Proposal for draft 08 series of amendments to UN Regulation No. 107 (as adopted by GRSG at its 112th session)

Submitted by the expert from OICA

The text reproduced below was prepared by the expert from OICA to amend UN Regulation No. 107 to include transitional provisions into the amendments adopted at GRSG-112 per document GRSG-112-35, to improve the accommodation and accessibility for passengers with reduced mobility. The modifications to the current text of the 07 series of amendments to UN Regulation No. 107 are marked in bold characters for new and strikethrough for deleted characters.

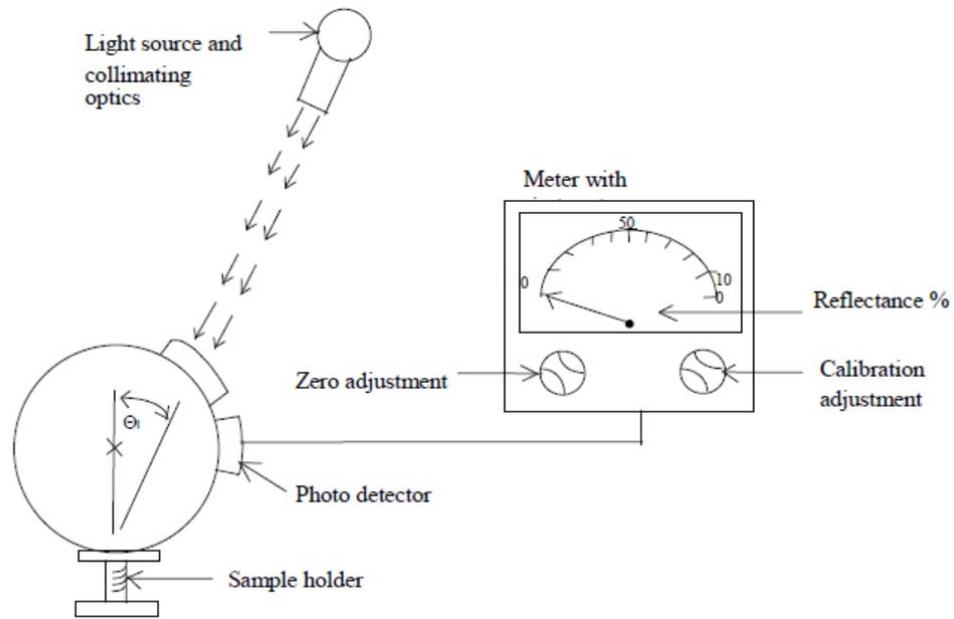
2. For determination of the reflectance values ρ_1 , ρ_2 and ρ_d an integrating sphere according to CIE 38:1977 shall be used.

The reflectance shall be either read directly from the indicating instrument or calculated according to the following formula:

- 2.1. The illumination angle of the luminous flux of the incident light on the sample Θ_i shall be equal to $8^\circ \pm 0.5^\circ$.
- 2.2. The luminous flux of the incident light on the sample shall be determined by using a diffuse reflectance standard calibrated by an accredited laboratory. The extended measurement uncertainty shall be lower than 3 per cent.
4. Example of an integrating sphere according to CIE 38:1977:
